Daimler Trucks

North America LLC Customer Advisory Letter

Subject : Rear PTO Pump Support

Date; 2-25-19

Subject; Rear Transmission Support Bracket

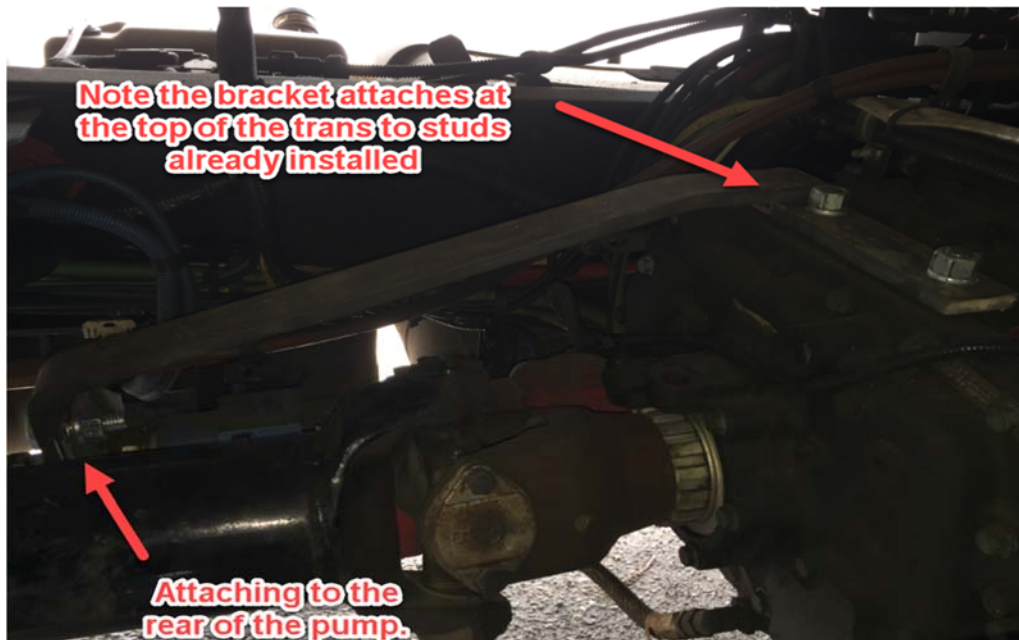
Issue; PTO Support

Those Fuller transmissions with the PTO rear mounted with a HYD Pump mounted to the PTO. There were some mounted with a support strap attaching to a single 3/8 bolt at the top of the transmission to one of the pump studs. We now have a support bracket that can be ordered from the location below that will bolt to the 2 - 5/8" studs from the top of the transmission and to the rear of the pump. The pump should have 2 studs, if they are now installed on the top of the pump, remount where the bracket will attach.
